## Circuit Revision Change to the XC9500XL Family of CPLD Devices

PCN2004-25 (v1.1) January 24, 2005

Product/Process Change Notice - FYI

Design Circuit  
Revision Code

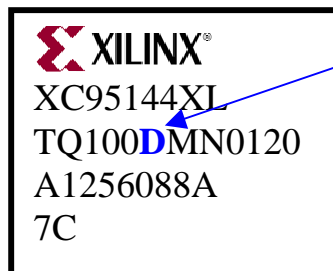
As part of the Xilinx continuous improvement process, a new circuit revision is being released for each member of the XC9500XL family of CPLD devices. This new circuit revision increases the tolerance of the configuration circuitry to non-monotonic power supply ramps and provides a more robust solution in customer applications. This revision is backward compatible to the revision C material that is currently shipping in production. The new circuit revision can be identified by design circuit revision code D (see *Traceability* below).

The design circuit revision code on the package topmark can be found as shown below.
